Addendum #4
Project #2767A
Brown County Port Development Project
Port & Resource Recovery
October 31, 2025
Request for Bid

Addendum #4

- To start answering questions received for project

SM504

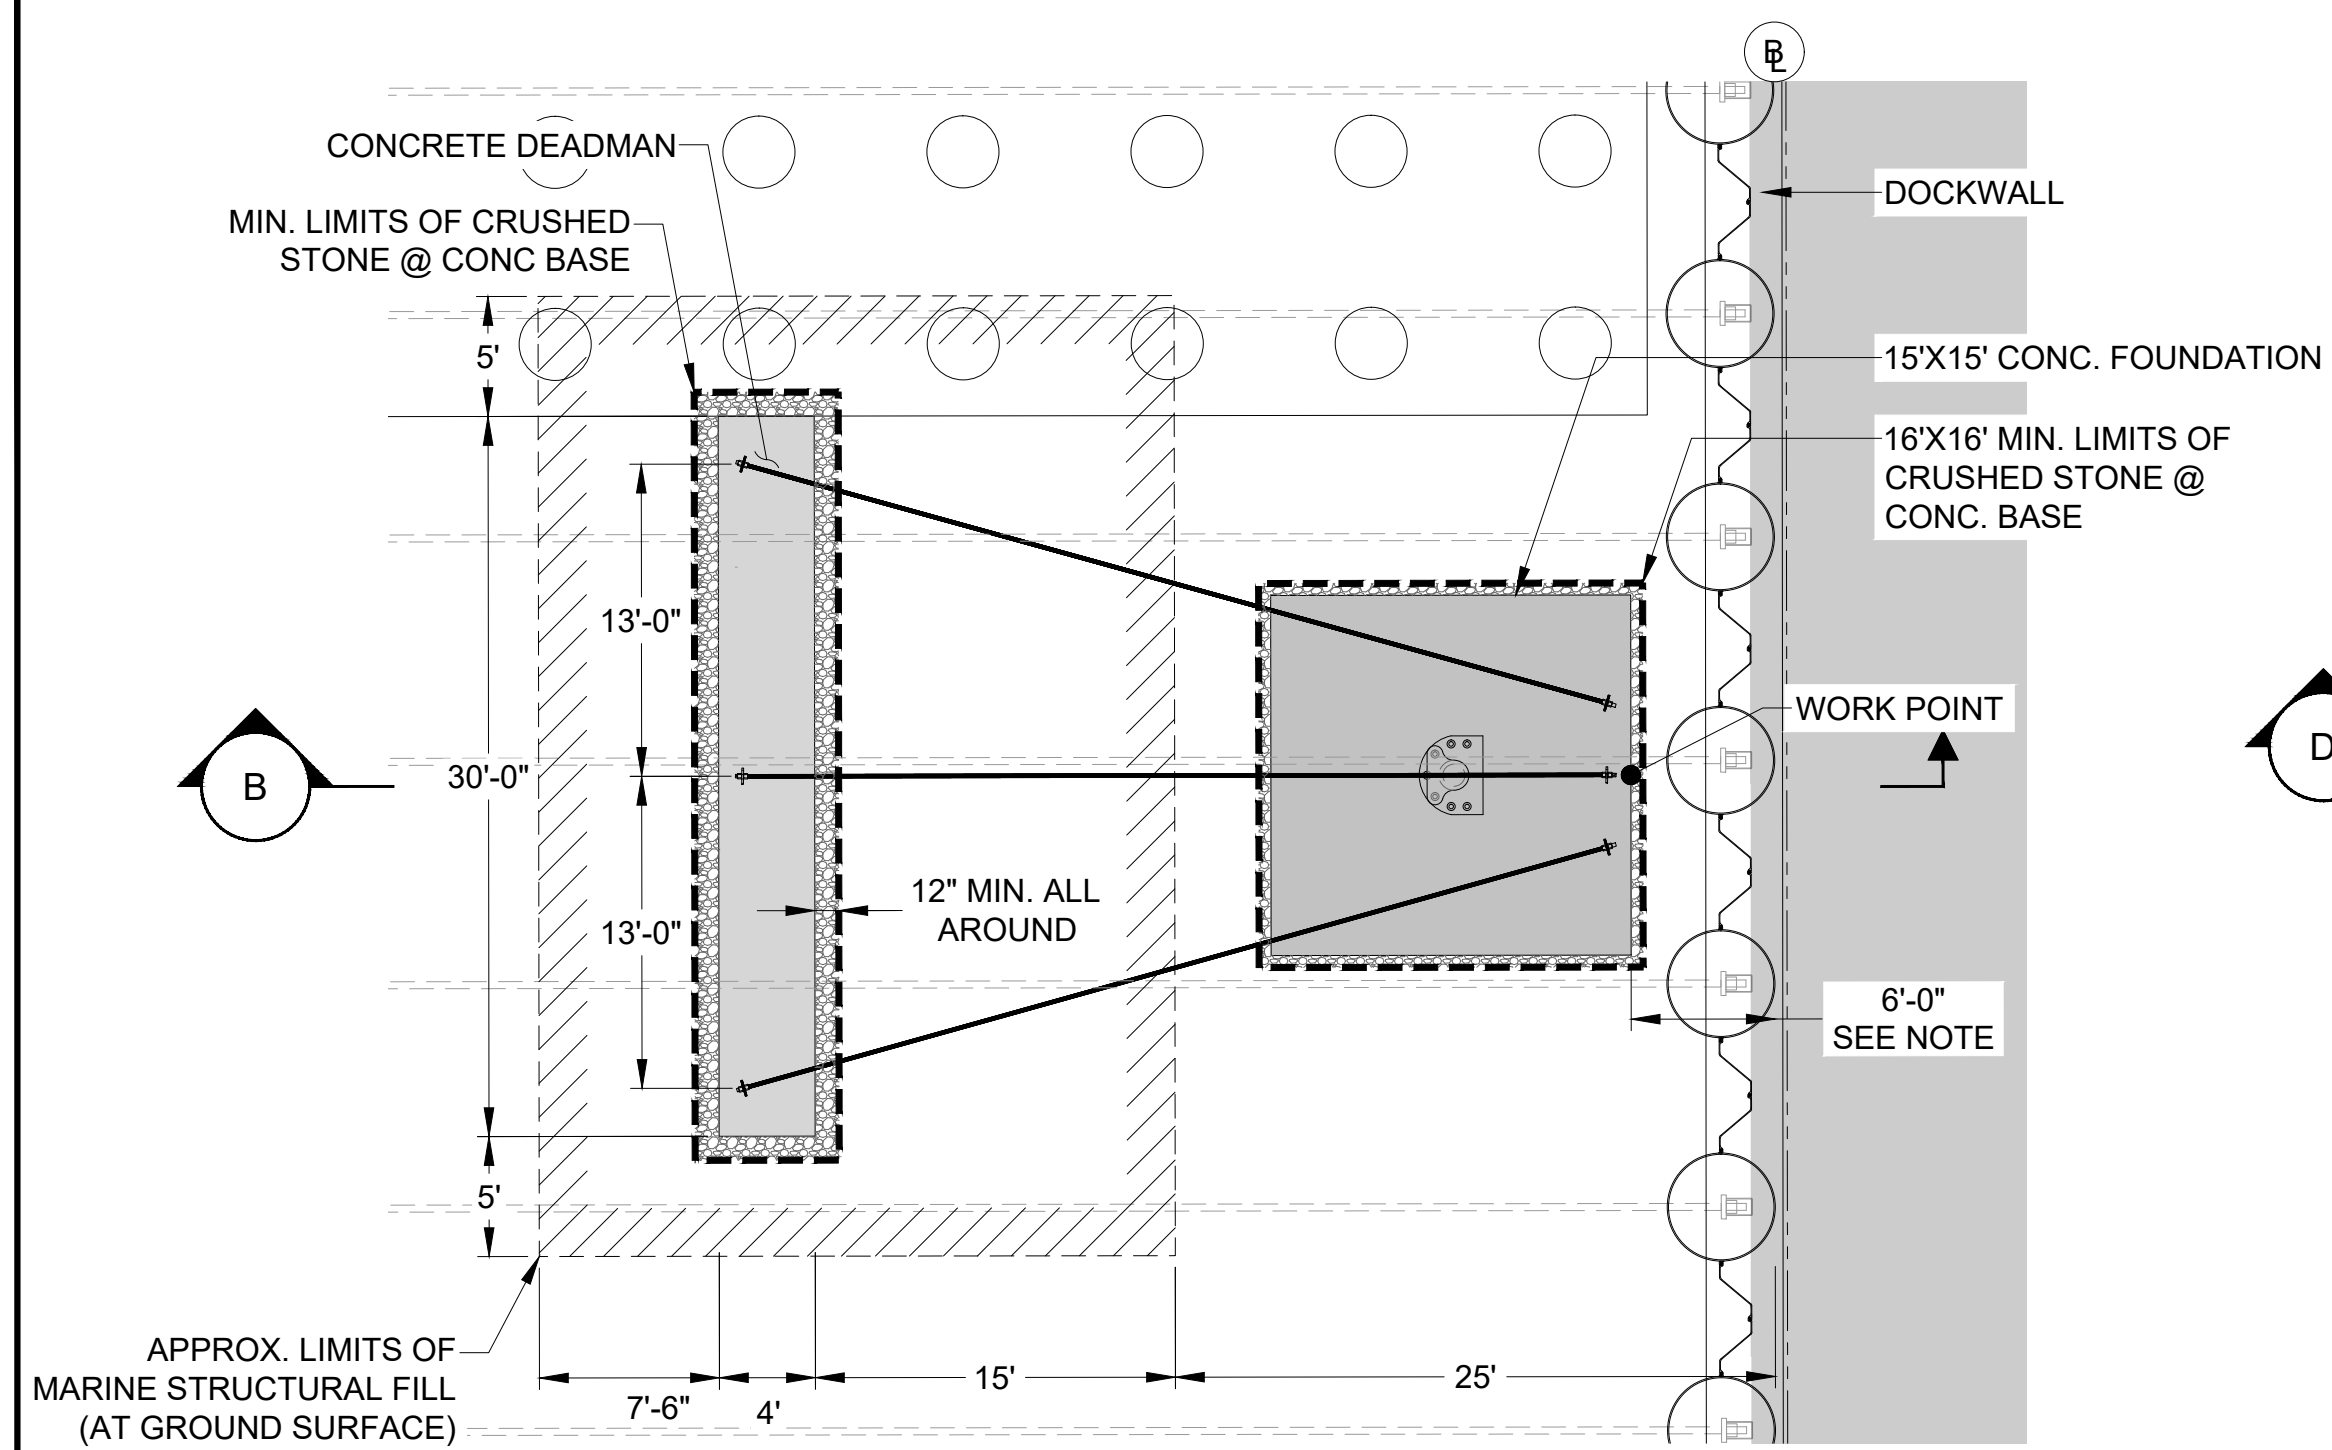
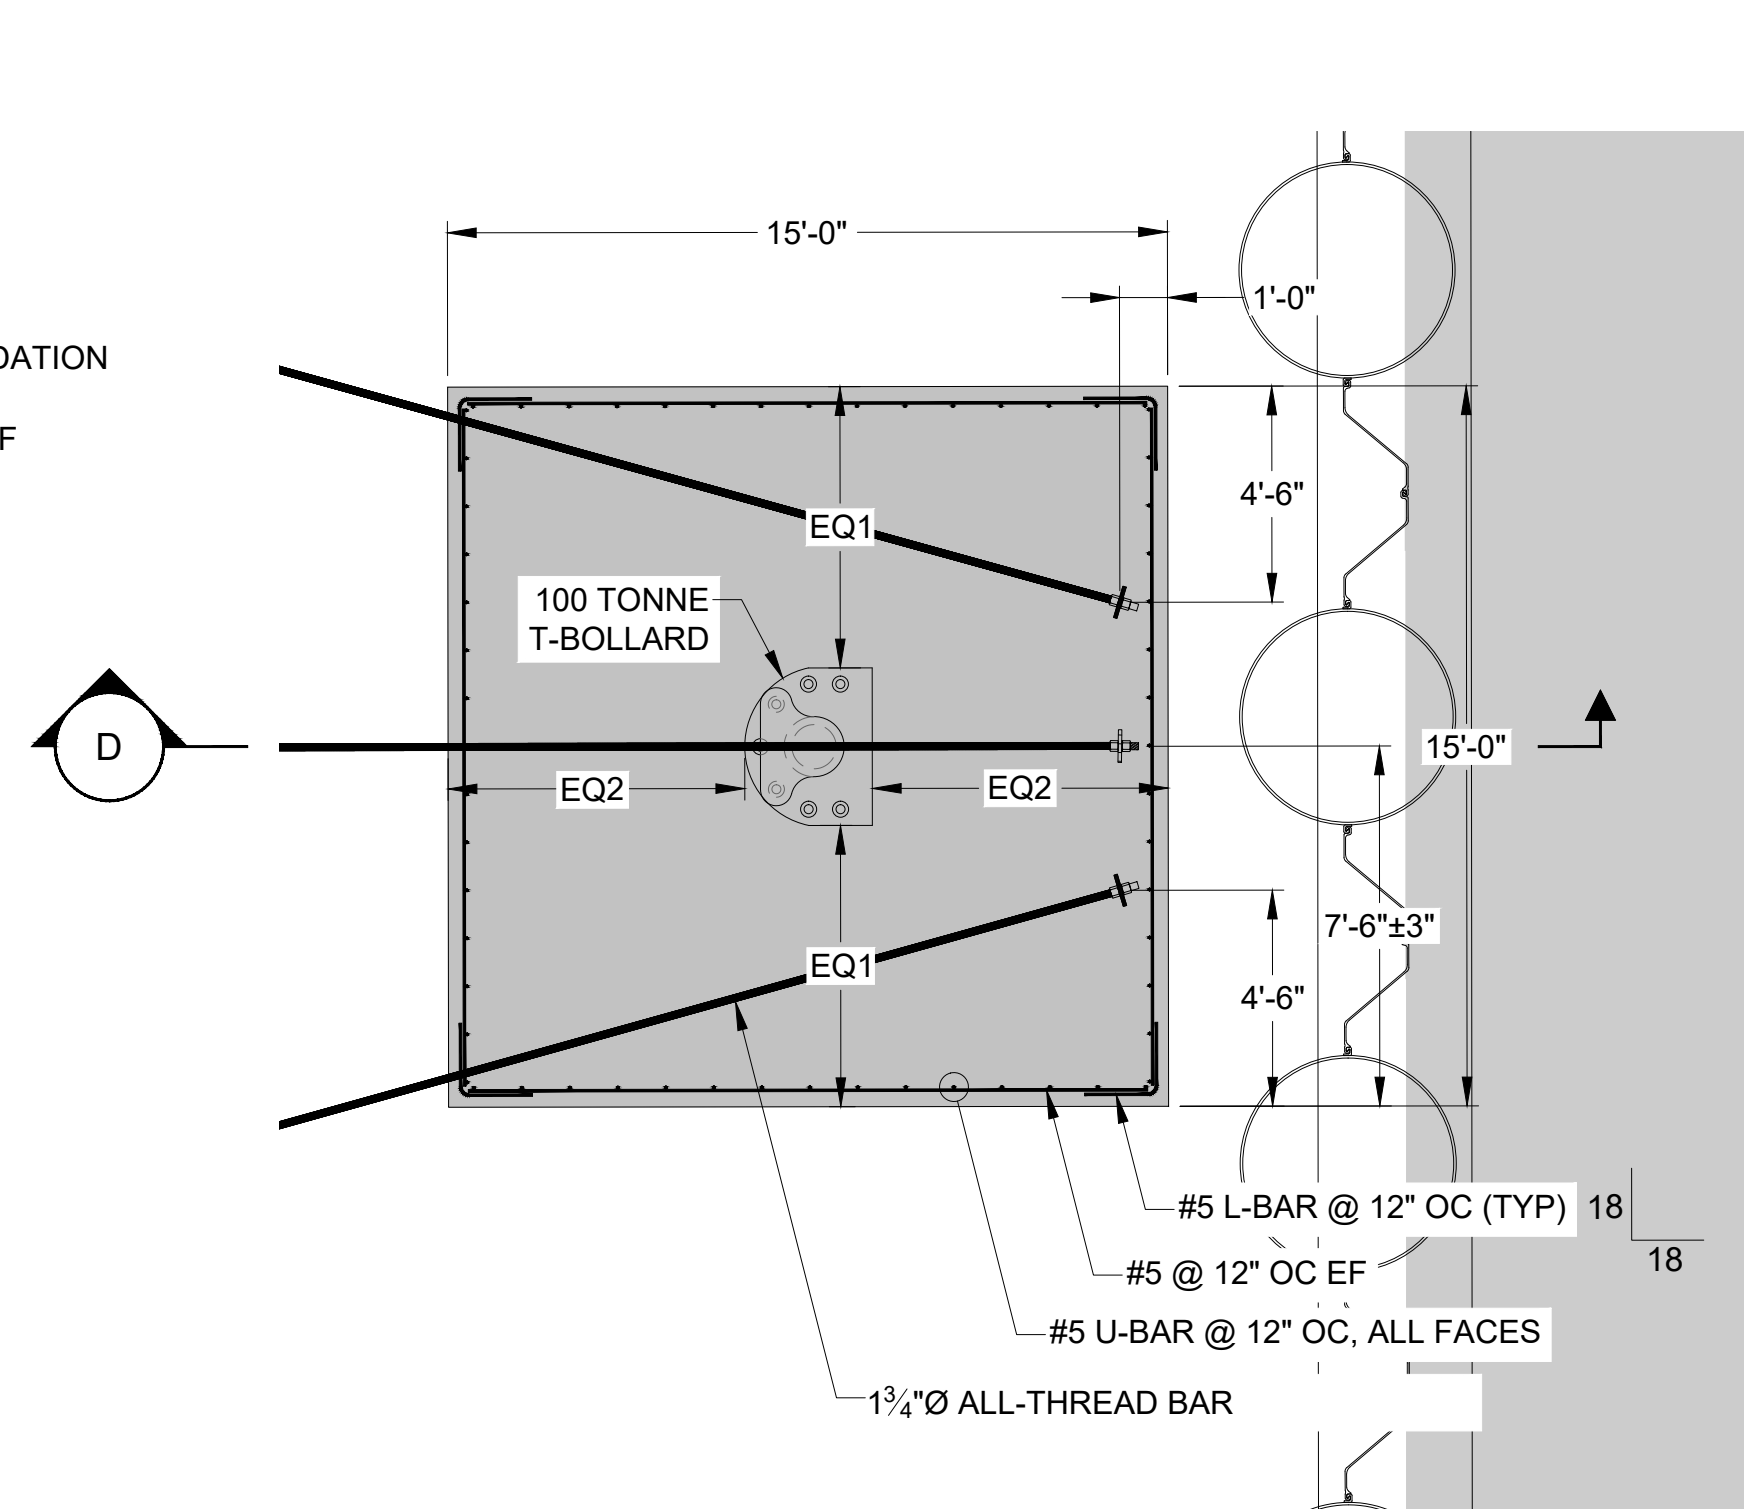
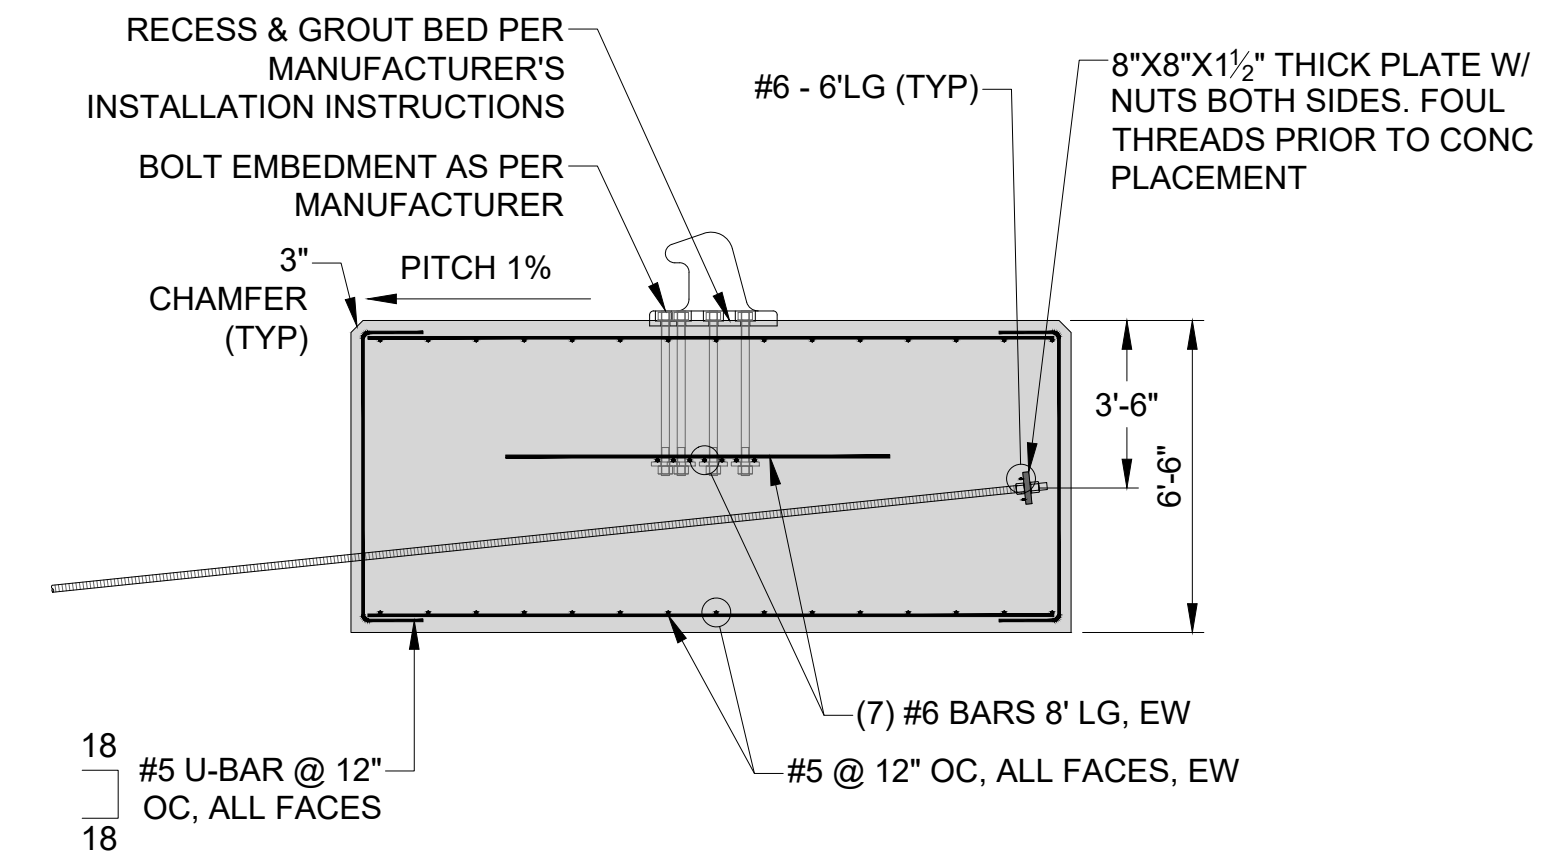
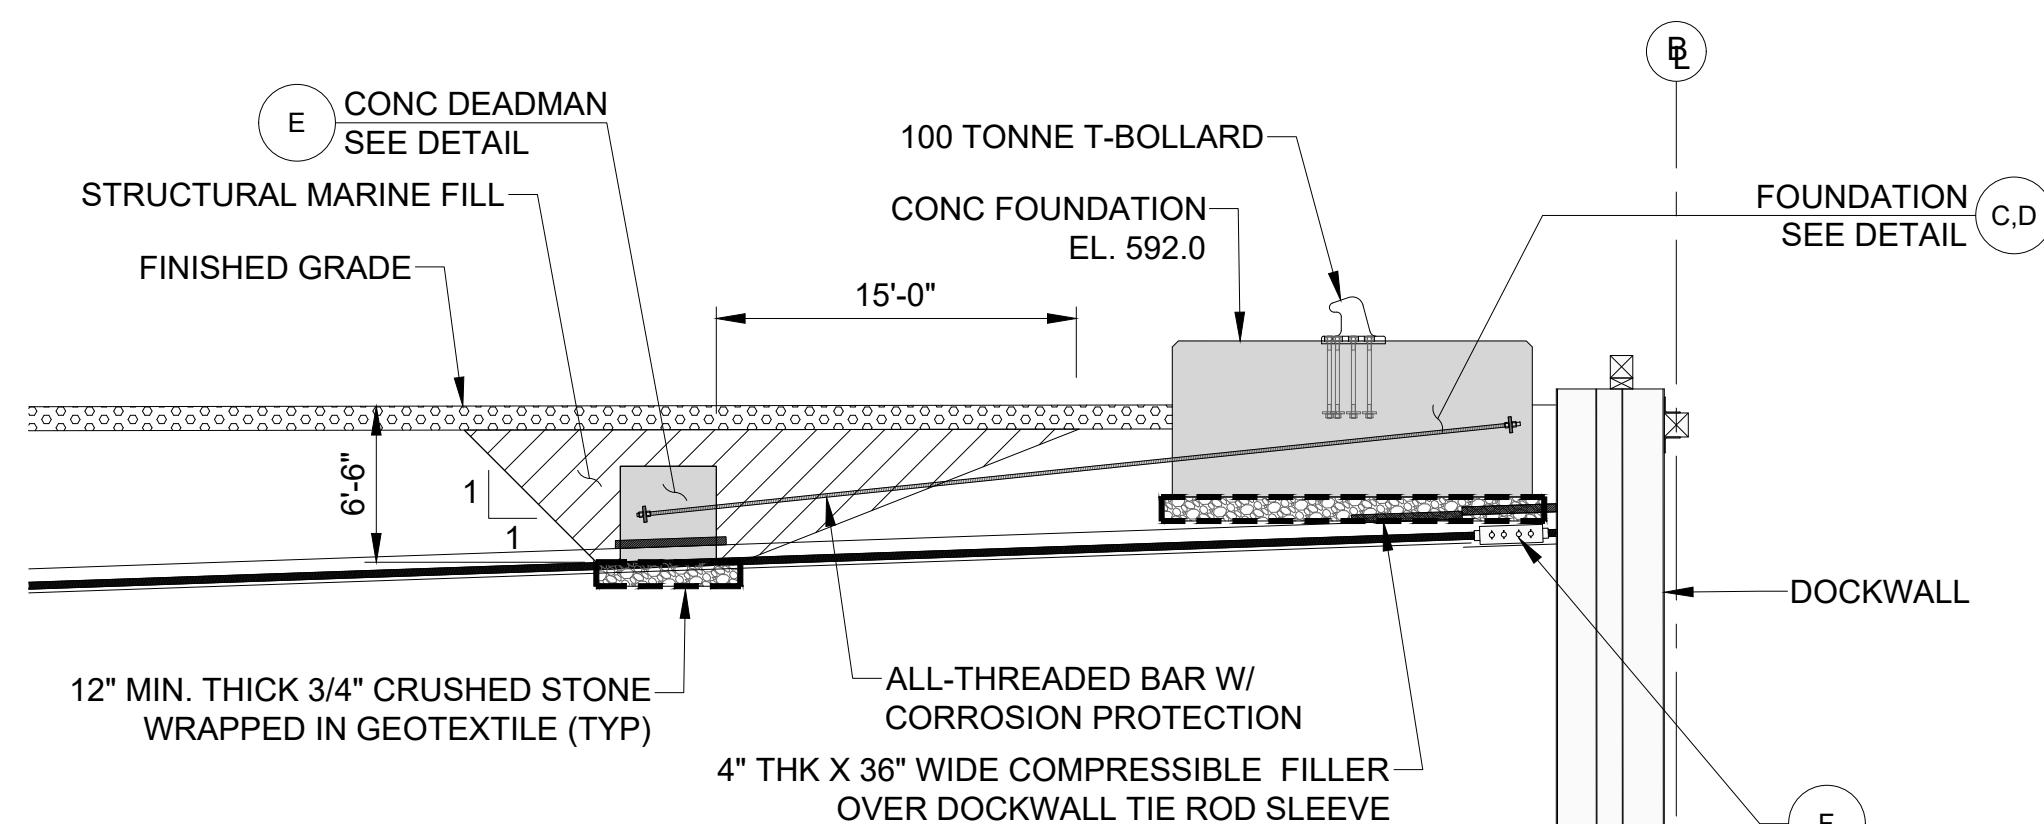
5. **QUESTION:** Attachment B item 3.3 Mooring Bollards The qty shows 17 ea. Drawing SM101 shows 16 ea. Please confirm what quantity is correct.

RESPONSE: There should be one additional bollard on the far north end of the dock wall for securing the end of the ship, resulting in 17 bollards. Sheet SM-101 has been revised to include this additional bollard.
